UNITED STATES PATENT AND TRADEMARK OFFICE

APPLICATION NO.	FILING DATE	FIRST NAMED INVENTOR	ATTORNEY DOCKET NO.	CONFIRMATION NO.
10/687,921	10/20/2003	Yao-Ching Su	025789-00010	8340

Office Action Summary	Application No. 10/687,921	Applicant(s) SU ET AL.	
	Examiner WILLIAM L. BODDIE	Art Unit 2629

DETAILED ACTION

FIG. 8

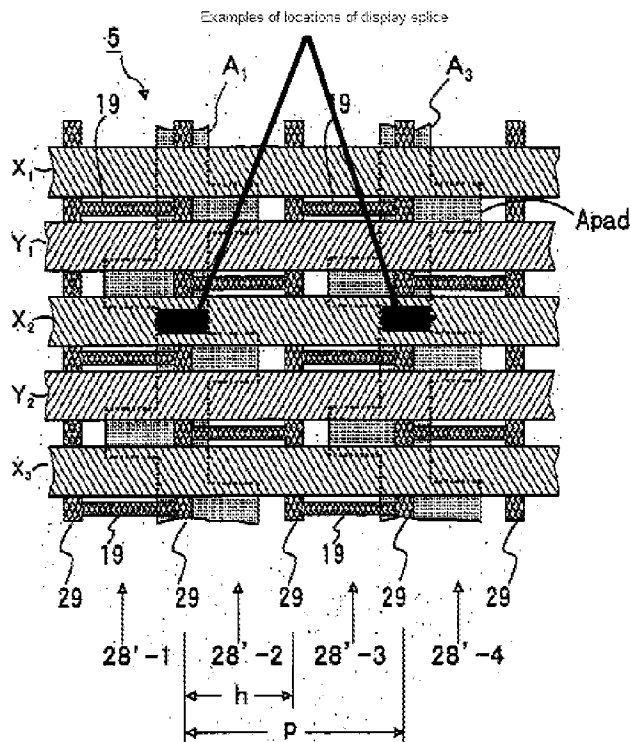
Kosaka does not expressly disclose that the gap is less than 40% of the cell length.

Based on figure 12, it is clear that Kosaka intended that the alternating protrusions of the data electrodes continue from one half of the panel to the other. With this in mind, we turn to figure 8, where when the data electrodes are split it should be clear that there would be a gap between the row ribs, 19, and the data electrode. Unless an entire row of pixels is to be lost, the gap will be less than 40% of the cell length. See the below annotated figure for further explanation.

Therefore it would have been obvious to one of ordinary skill in the art to make the display splice in a manner to ensure that the gap between a rib and data electrode is minimized to ensure proper discharge of the last pixel that the data electrode is present in. Thus the decision to design the plasma panel so as to achieve a gap of less than 40% is seen as an optimum range that would have been obvious to one of ordinary skill in the art at the time of the invention.
